# TEAC<sup>®</sup> AMERICA, INC.

## MOTOR REPLACEMENT:

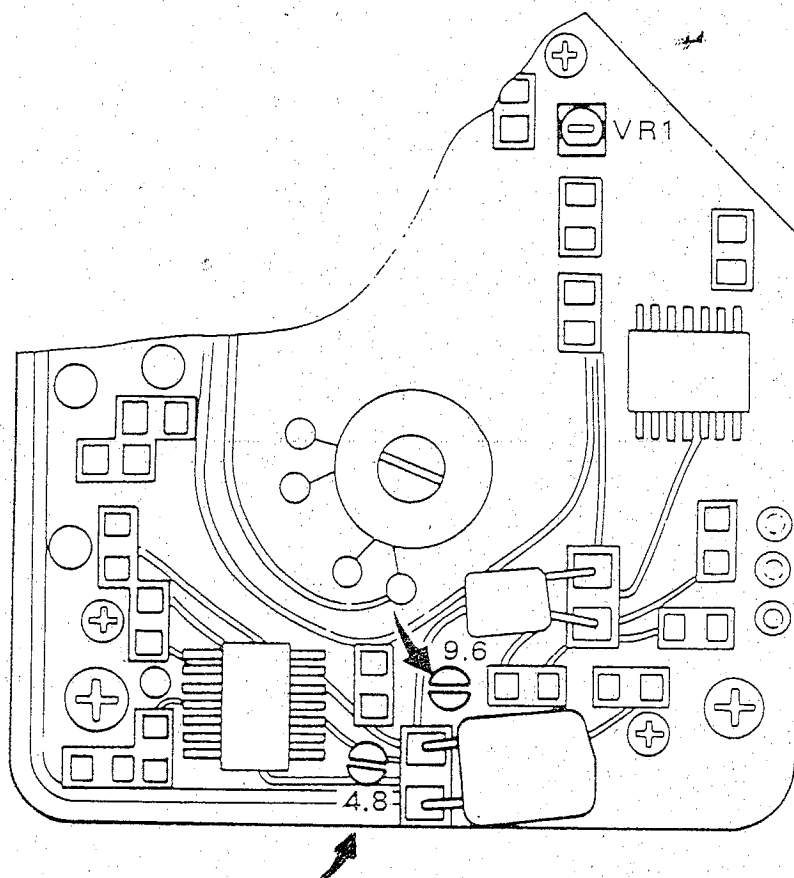
- MODEL 122MKII - SHORT, BY SOLDER, THE CONNECTOR MARKED "4.8"
- MODEL 238 - SHORT, BY SOLDER, THE CONNECTOR MARKED "9.6"

**CAUTION:** After replacement of the capstan motor assembly, be sure to short-circuit (by soldering) the points on the assembly shown by the arrow in Fig. 4-10. Otherwise, correct tape speed adjustments are not ensured.
